Work Order ID-67355

Item Name: Replacement Skidtube

DESIGN <i>[Signature]</i>	DRAWN BY <i>[Signature]</i>	DART AEROSPACE LTD HAWKESBURY, ONTARIO, CANADA	
CHECKED <i>[Signature]</i>	APPROVED <i>[Signature]</i>	DRAWING NO. D2580	REV. D SHEET 1 OF 3
DATE 07.02.27		TITLE 205 SKIDTUBE ASSEMBLY	SCALE NTS
A	96.09.16	NEW ISSUE	
B	96.12.02	AS MANUFACTURED	
C	98.08.26	REDRAWN, INCLUDED DEO 9094/9097	
D	07.02.27	CHANGE TO SS WEARPLATES AND GASKETS, INCLUDE DEO 9124/9183

DRAWING NO. D2580	TITLE 205 SKIDTUBE ASSEMBLY	REV. D	DART AEROSPACE LTD ENGINEERING ORDER		D.E.O. NO. D2580-D-1	SHEET NO. SHEET 1 OF 1	SCALE NTS
DRAWN <i>UP</i>	CHECKED <i>L</i>	MFG. APPR. <i>E</i>	APPROVED <i>MP</i>		DE APPR. <i>H</i>		
DATE 10.09.22	DATE 10.11.04	DATE 10.11.04	DATE 10/11/04		DATE 10.11.04

SECTION D-D & SECTION H-H ARE AMENDED AS FOLLOWS:

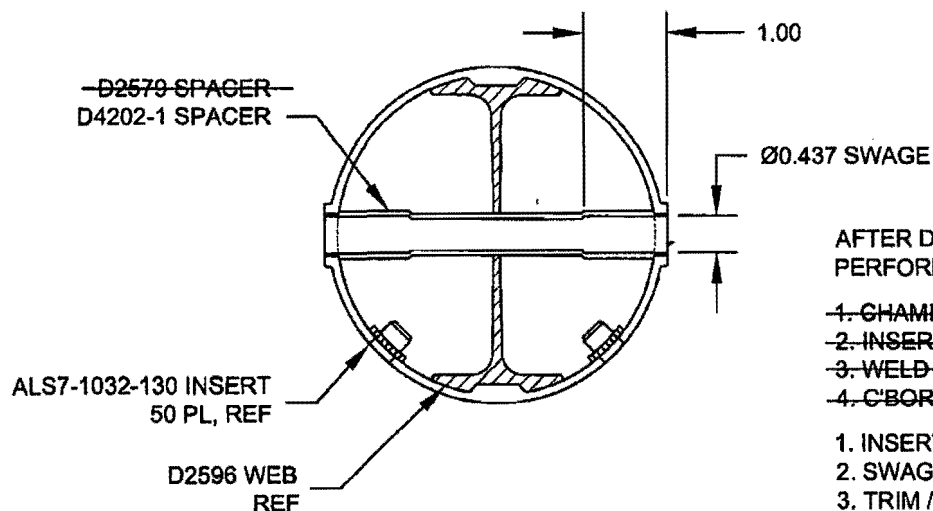
CHANGE ALL WELDED CROSSBOLT SPACERS TO SWAGED SPACERS

WAS

QTY	QTY	PART NUMBER	DESCRIPTION
-041	-045		
20	24	D2579	CROSS BOLT SPACER

1. CHAMFER HOLE 0.050 X 45°
2. INSERT D2579 SPACER (20 PLACES)
3. WELD INTO PLACE AND GRIND FLUSH
4. C'BORE D2579 SPACER TO Ø0.437 X 1.00 DEEP

IS

20	24	D4202-1	SPACER
----	----	---------	--------

1. INSERT D4202-1 SPACER, 20 PL (-041) OR 24 PL (-045)
2. SWAGE TO Ø0.437 X 1.00 DEEP PER QSI 002
3. TRIM / GRIND FLUSH PER QSI 002
